Charlotte Historic District Commission

Staff Review

HDC 2018-523

PROPERTY ADDRESS: 517 Walnut Avenue

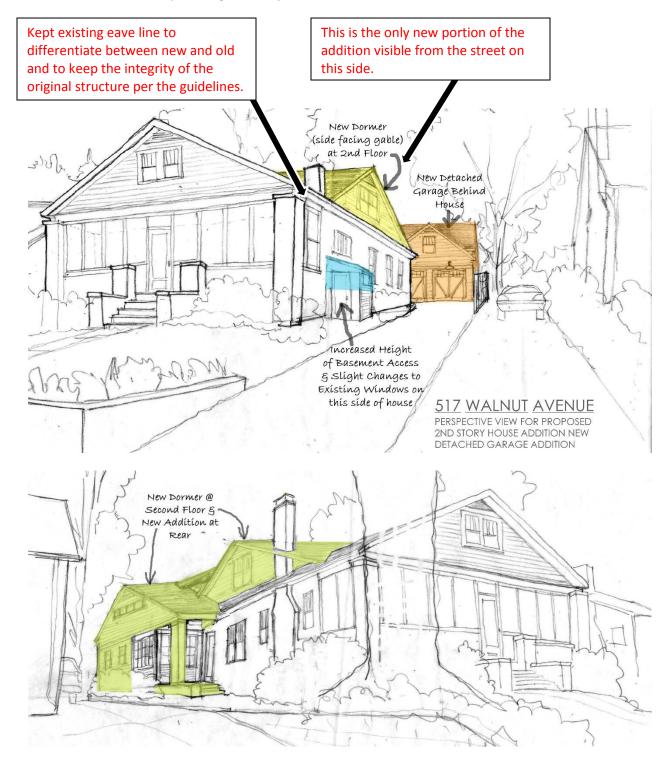
- ✓ 7.2.4-(See Image Below) We have maintained the original orientation of the main front facing gable and it will not be changed.
- ✓ 7.2.5-(See Image Below) Maintained the existing roof pitch on all new roofs as close as possible with the exception of the shed roofs which are all on the rear of the house and not visible from the street. And the original roof at the front has been maintained and will still be the prominent view of the house from the public right-of-way.

- ✓ 7.2.6-(See Image Above) All roof slopes, materials, form, massing, and scale, directional expression, and roof forms are compatible with the current roof line and other similar homes in this neighborhood as well as other nearby neighborhoods built at the same time. Please see the roof form studies that show nearby and historic examples submitted as part of this package as well as homes previously approved by the HDC with almost identical roof lines included in the presentation materials for 719 Tremont Ave and 812 Lexington Ave.

- 7.2.7-(See Image Above) The new roof proposed at the rear is slightly taller than the original roof (3'-8") to meet head height requirements for the NC Residential Building Code for the new second floor spaces but this roof is sloping back away from the street, and the top of the new ridge is more than halfway back on the existing structure, the house is about 8-10ft above the elevation of the public right-of-way and we do not feel it will have a large visual impact from the street and will not overpower the existing roof line and front gable which will still "read" at the dominant roof feature.

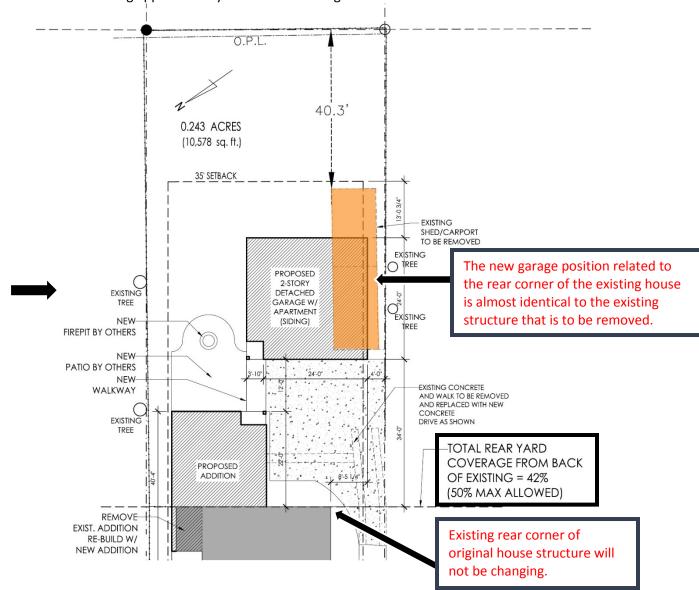
- 7.2.8-(See Image Below)—No more than 50% of the rear yard from the back of the existing structure can be impervious area including additions, accessory buildings, patios, driveways, etc. We are covering approximately 42% with this design.

Section 8: Accessory Buildings

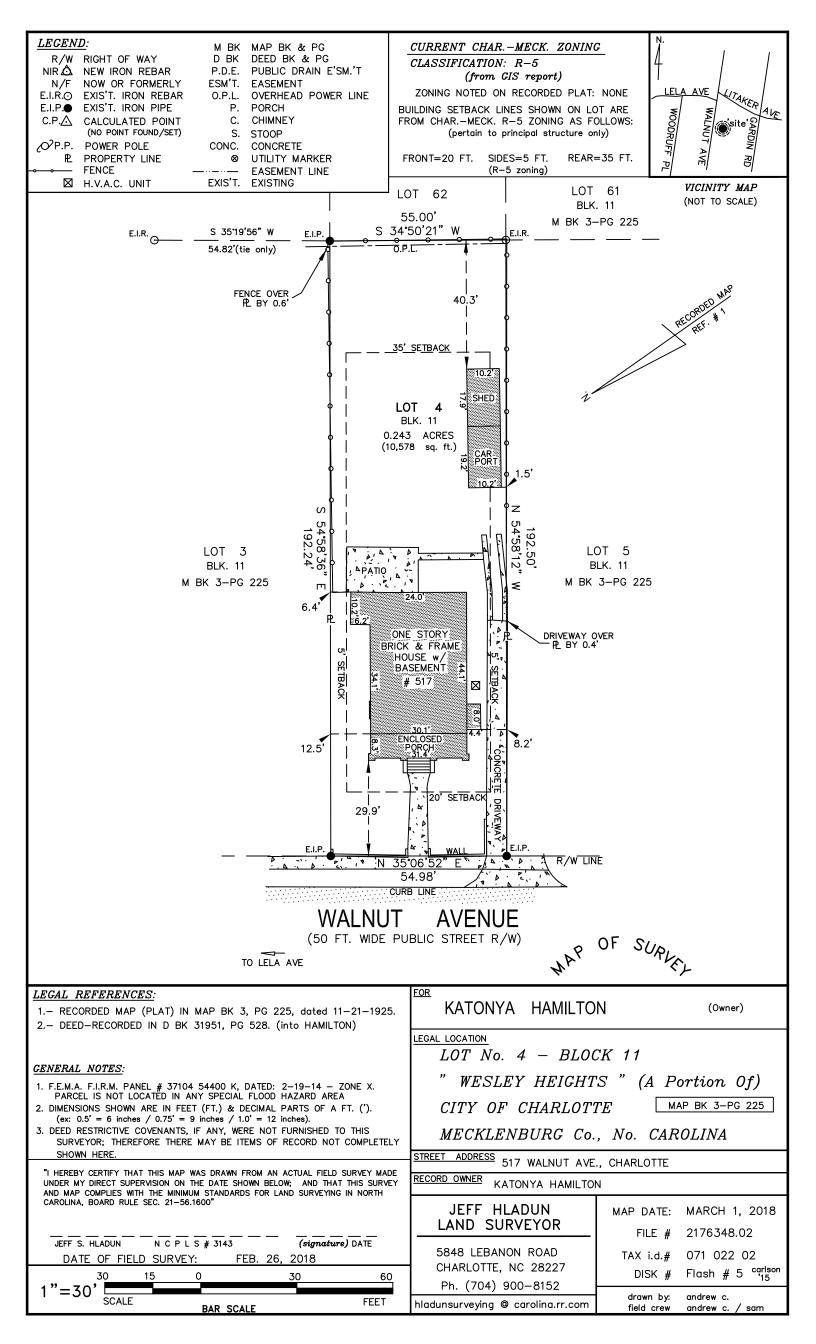
- √ 8.9.2-(See Images Above & Below) The garage is sited at the rear. Detached structured were usually just beyond the house and not pushed completely to the rear. Also...pushing it back further will result in more concrete. We are near the limit of the rear yard coverage currently at 42% coverage as drawn.
- 8.9.3- (See images already included Section 6 & 7above) New garage is designed to be compatible with the historic style, character, historic elements, and roof form. The scale is quite a bit smaller than the primary structure and situated far enough behind the house to read as secondary and as a 1 story or 1.5 story structure the same as the primary structure. And roof height is 12-18" lower than the primary structure.

HDC Approved Project 719 E. Tremont Ave.-Dilworth

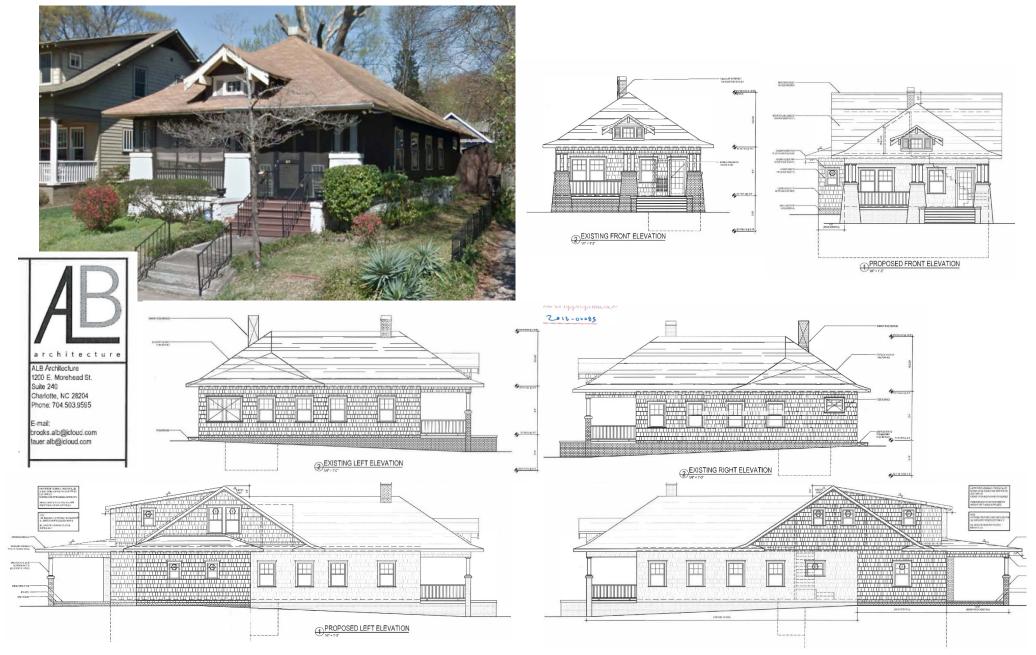
This project was an <u>approved by the Historic District Commission in May 2018</u> for an addition/change to the existing roof line that proposed a new side facing gable with a new ridge height higher than the original front facing hip/ridge in Dilworth. House was originally built in 1900. Not sure if this project was ever completed but was approved under the current HDC guidelines. 517 Walnut was built in 1933, very similar original roofline, proposing similar exterior modifications.
